February 22, 2010  
U7-C-STP-NRC-100044

South Texas Project  
Units 3 and 4  
Docket Nos. 52-012 and 52-013  
Response to Requests for Additional Information

Attached are responses to NRC staff questions included in Request for Additional Information (RAI) letter numbers 232, 239, and 314 related to Combined License Application (COLA) Part 2, Tier 2, Section 4.4 and Appendices 6C and 15A. This completes the response to these letters. The attachments address the responses RAI questions listed below:

Figure 6C-2 Core Inlet Delta-P for Blocked and Unblocked Cases

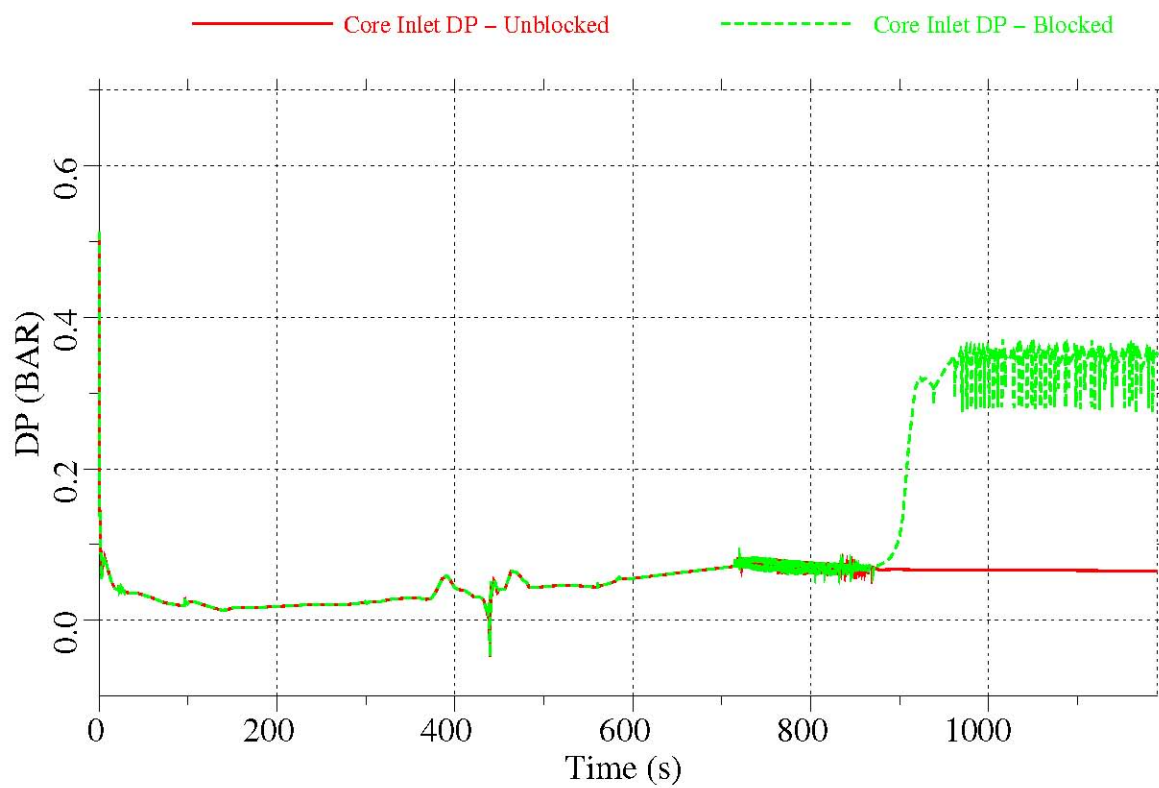
In response to RAI 06.02.02-2, STPNOC in their letter dated Sept 28, 2009 (U7-C-STP-NRC-090141) agreed for a COL license condition to submit an evaluation as part of the license amendment confirming that the fuel for the initial fuel load satisfies the downstream effects of containment debris on the reactor fuel. The acceptance criteria specified in the response are not sufficient.

- a) Provide verifiable criteria for the fuel testing. Revise FSAR Section 4.4 to include the details of the acceptance criteria.
- b) Confirm that the protective coatings debris characteristics for fuel assembly tests will be consistent with the NRC guidance for operating PWRs (NRC Staff Review Guidance Regarding Generic Letter 2004-02 Closure in the Area of Coatings Evaluation, March 2008, ADAMS Accession No. ML080230462.) For example, if a filtering bed is possible on fuel assembly openings, then fine particles representing coatings debris would be included in the debris load. In addition, show how the test requirements will be included in the application (e.g., license condition wording).

Figures 6C-2, 6C-3, and 6C-4 compare the core inlet DP, flow rate and void fractions for the cases with no blockage and with blockage resulting in a reduction of flow area by 90% of inlet flow area. Five minutes is the estimated amount of time required for the debris in the system to start to reach the fuel filters. The models assume clogging begins at 850 seconds because that is when the flow through the core reaches a steady state. In order to ensure that any effects seen are caused by the changes being made, steady flow is required. Despite a very high level of blockage, sufficient flow remains available to the core to ensure that the core void fraction both in the hot assembly and average assembly remain  $< 0.95$ .
